210218 Planning Board Meeting  
HVSF Written Responses

March 4, 2021

Attached herein represent our responses to questions raised during the February 18, 2021 Planning Board Meeting. Our responses are comprised of the following:

Core Area Development Plan 1

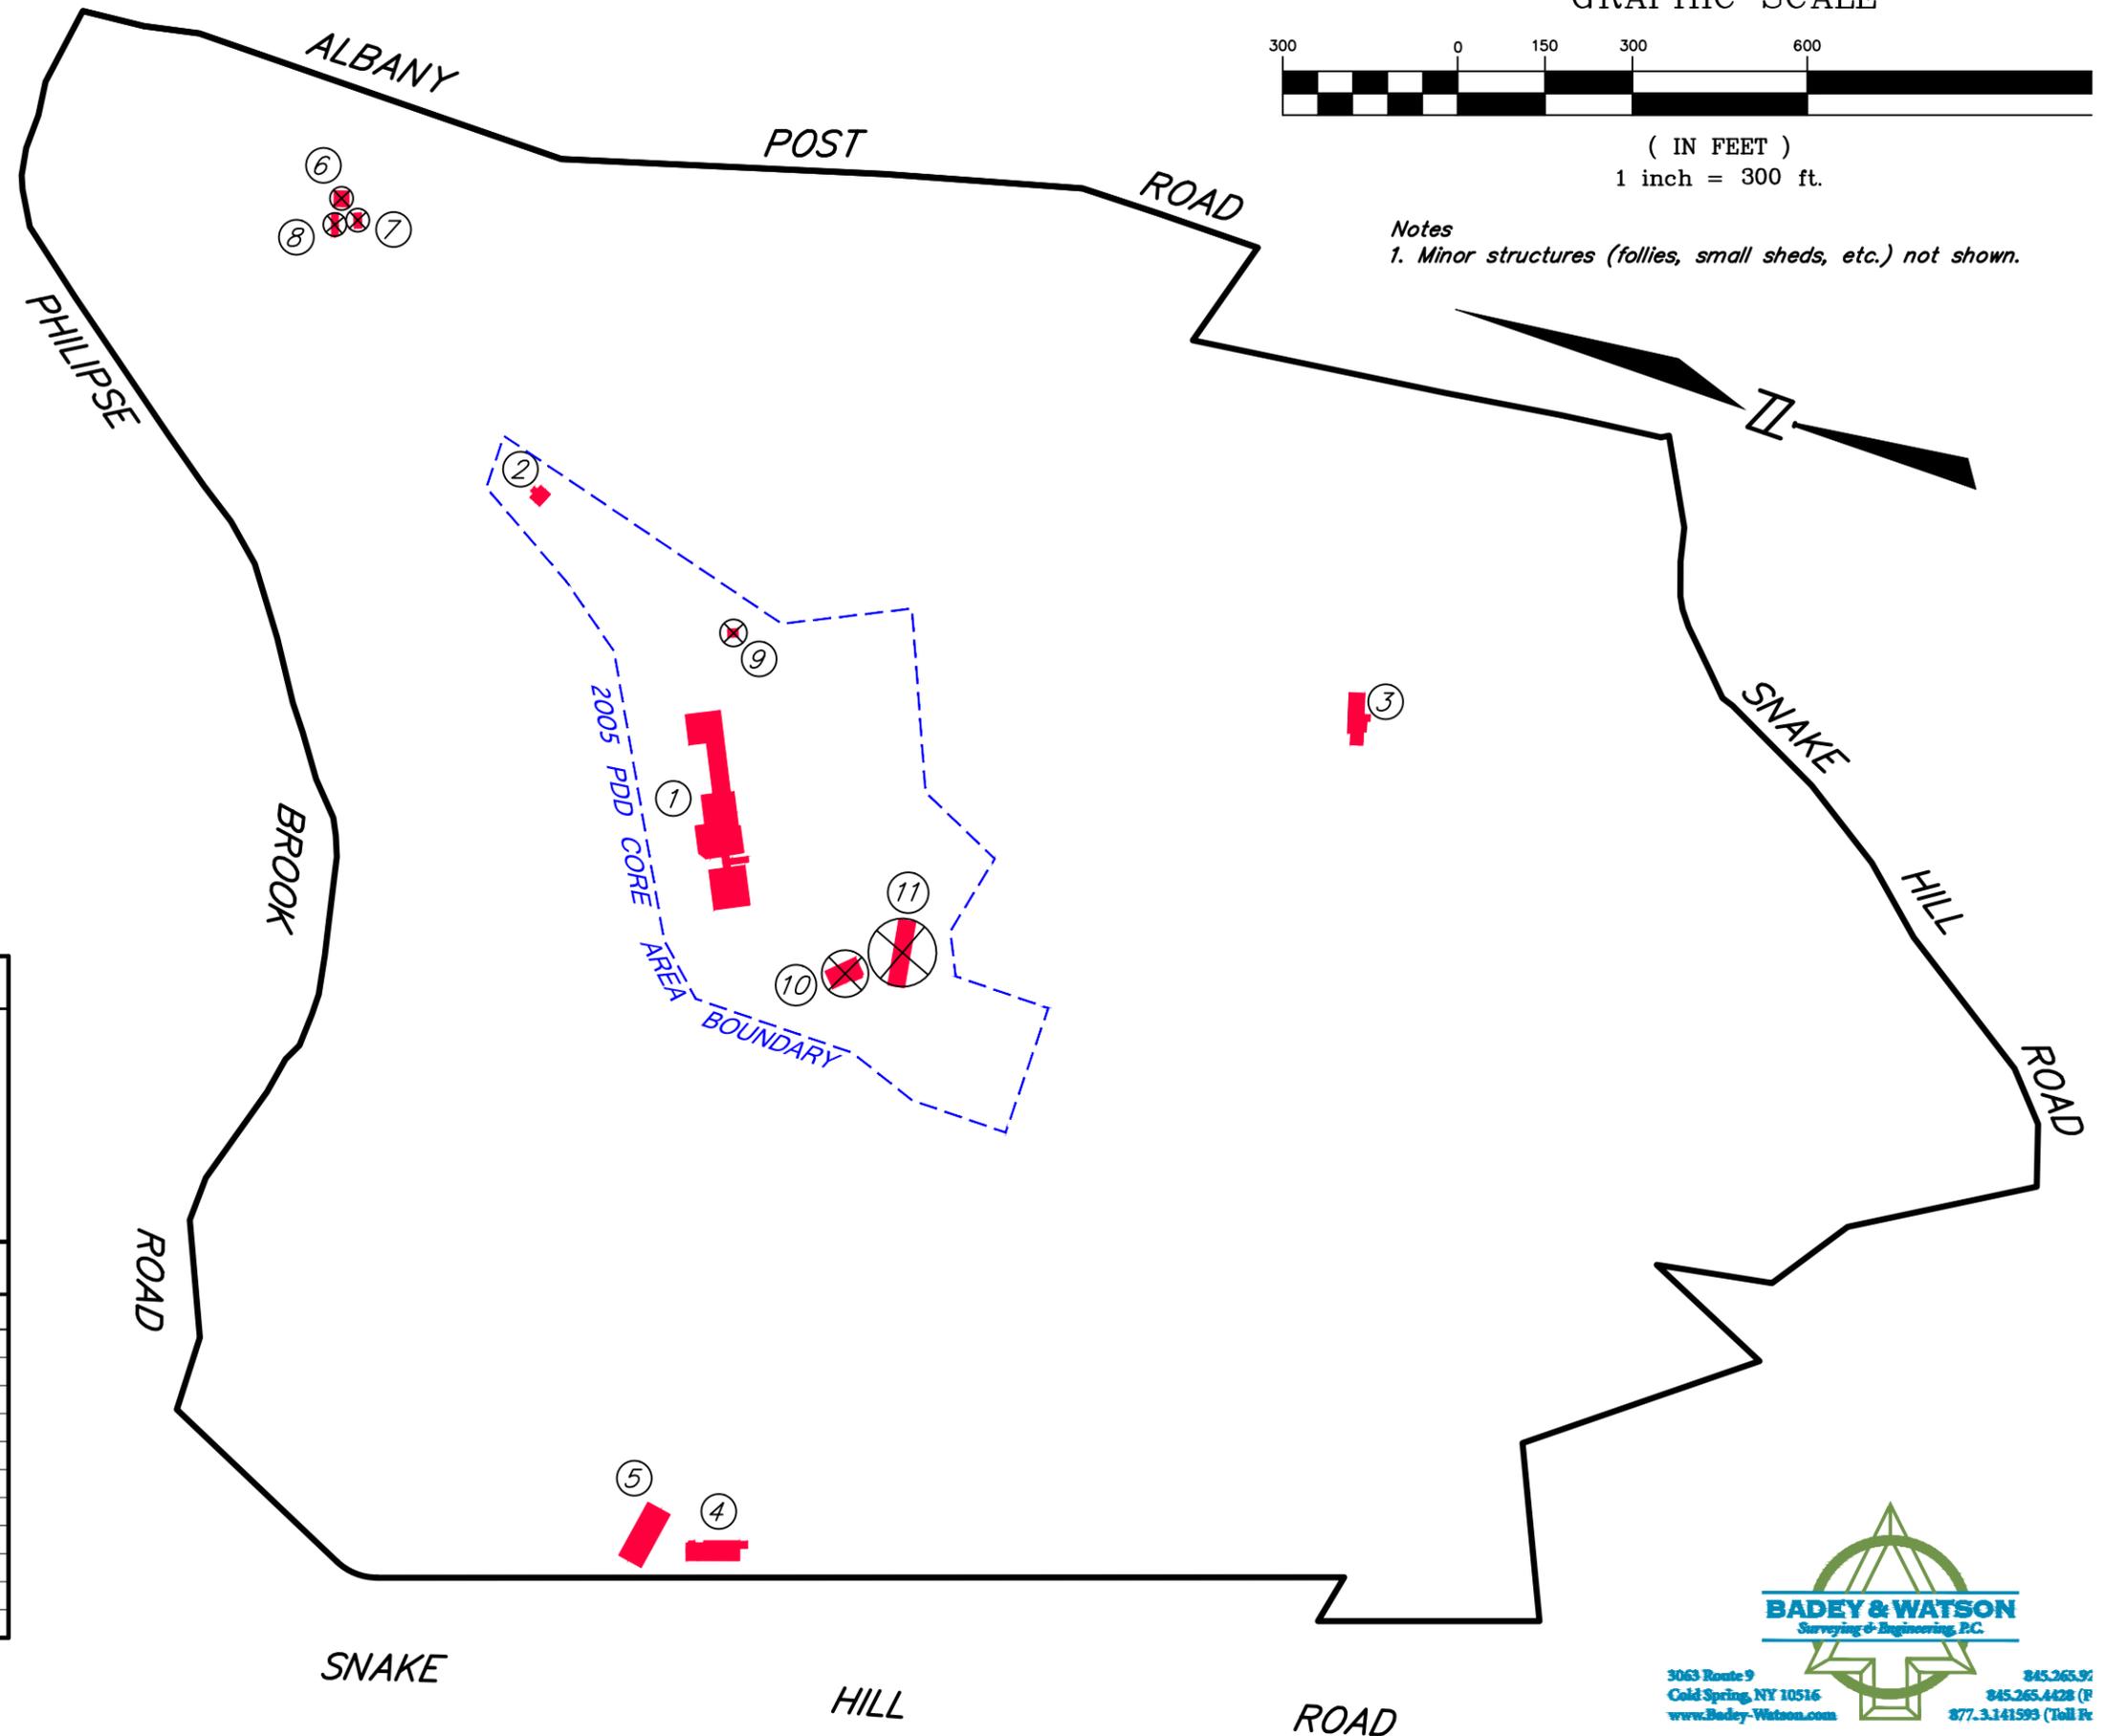
- Please provide a drawing that shows where the new plan is in relation to the core area identified in the prior PDD. **In addition to adding the original Core Area Boundary to the Landscape Architect's Plan, attached as Core Area development plan 1, a simplified 2 sheet plan set (Core area development plan 2) is also attached. This plan shows the Main Parcel Boundary, the 2005 Core Area and the following elements:**
